Peter Ridgeway

28/7/2017

Submission: Northern Road Stage 3 EIS

Remnant Trees – Orchard Hills

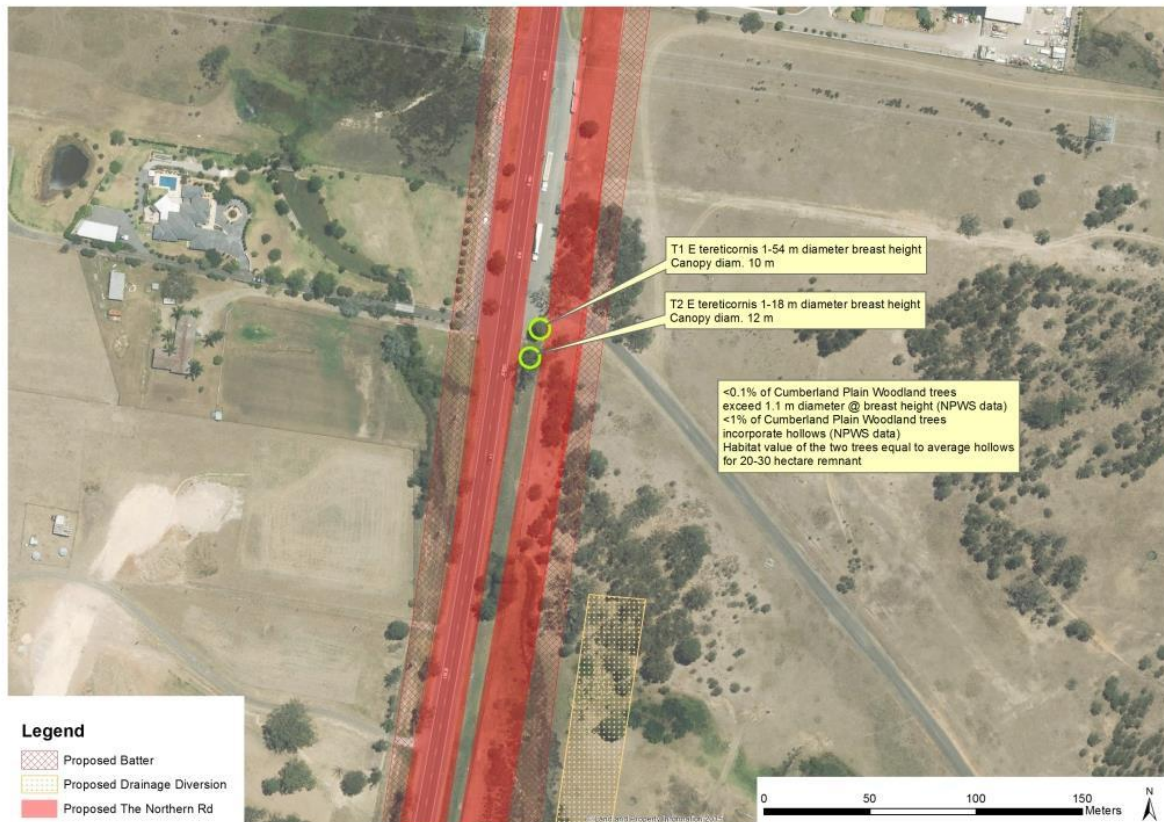
Two remnant trees are located on the current roadside beside the RMS inspection bay at Orchard Hills. These trees have significant local heritage value and form an integral part of the local aesthetic and character.

These trees are also of outstanding ecological value which has not been satisfactorily assessed in the EIS. The FBA and many non-local ecologists do not appreciate quite how significant such trees are in the Cumberland Plain. Remnant trees over 1.1 m dbh constitute a mere <0.1% of Cumberland Plain Woodland trees remaining (NPWS data, unpublished) and have the habitat equivalent (measured in useable hollows) of 20 -30 hectares of typical vegetation (NPWS data, unpublished). These two individual trees alone are of greater ecological significance than a number of the vegetation remnants considered under the FBA.

The Northeast tree is the largest with a diameter 1.54 m (Dec 2014), and the southwest tree about 10 m away a diameter of 1.18 m.

It is realistic and sufficiently important to retain these trees through the design & construction process. This opportunity should be pursued.

The EIS does not incorporate design drawings however subsidiary documents within the EIS show a preliminary design in which these two trees are located within the median strip. This alignment should be retained within the design process and median width & management maintained sufficiently to retain these trees in a safe manner.

- The old-growth remnant trees beside the RMS inspection bay at Orchard Hills should be retained for their outstanding ecological significance and as a key local aesthetic icon

Surveyors Creek Wildlife Corridor (general)

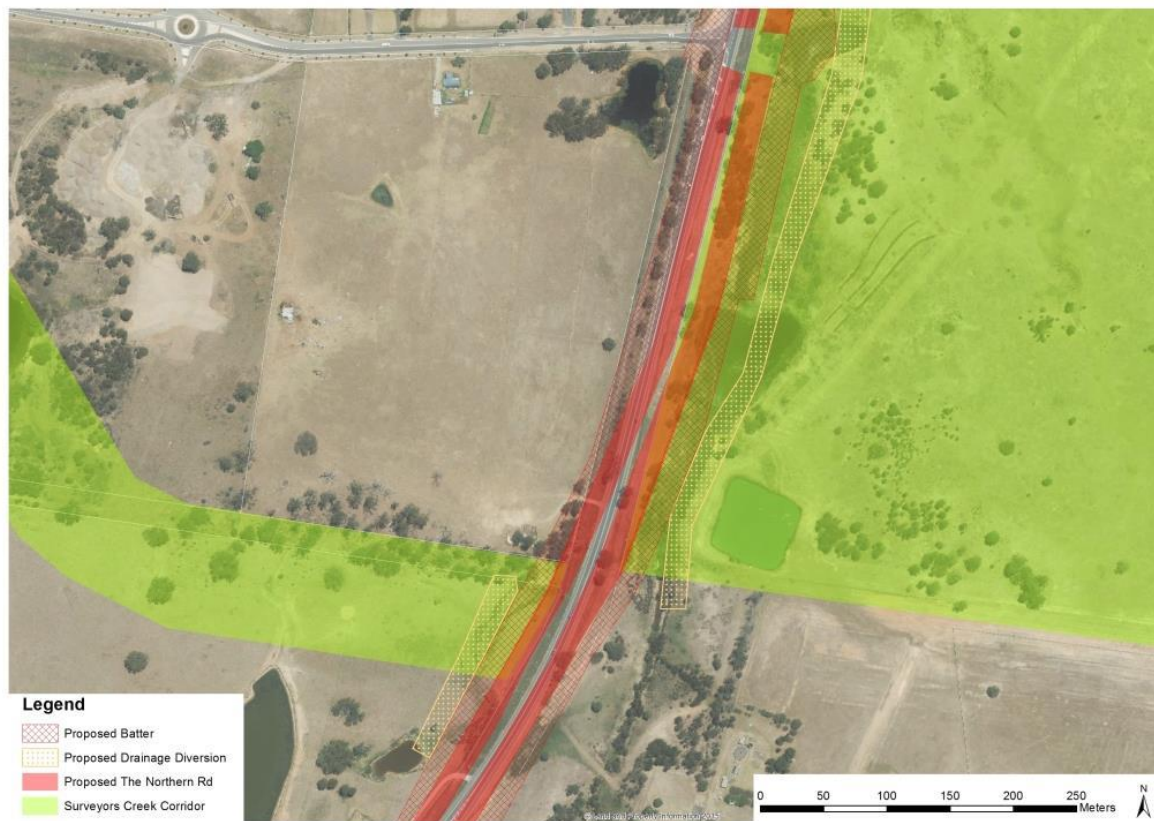
The 'Surveyors Creek Nature Reserve' is a dedicated wildlife corridor being constructed and transferred to Penrith Council through the development of Glenmore Park and surrounding suburbs. The corridor is as gazetted in the relevant Local Environment Plans and DCPs. Surveyors Creek Corridor constitutes Regional Corridor 17 of the NSW OEH BIO Map reflecting its significance as a critical local wildlife corridor. The BIO Map has some minor errors in alignment and the correct alignment as per the LEP mapping is shown below.

This corridor is of particular significance for two biodiversity matters. The first is for movement of obligatory altitudinal migrants Vulnerable Flame and Rose Robin as discussed above.

The second significance is for the movement of Eastern Grey Kangaroos. Individuals of the species regularly move between DEOH and Mulgoa Nature Reserve (despite DEOH fencing) but would be dislocated by the proposed development. This issue is further considered in the following discussion on a potential wildlife underpass.
